Technical Service Bulletin: tsb100626

Released Date: 03-Dec-2007

New Harness Mounted Ambient Air Pressure Sensor

- Old Style Sensor

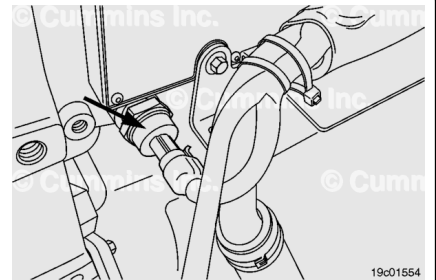
When replacing the complete main engine harness on heavy duty engines, there will **not** be a connector on the harness that connects to the old style engine mounted ambient air/barometric pressure sensor. The new engine harness will come with a new ambient air/barometric pressure sensor already attached to the new harness. The old style engine mounted sensor will **not** be used and can be removed and discarded.
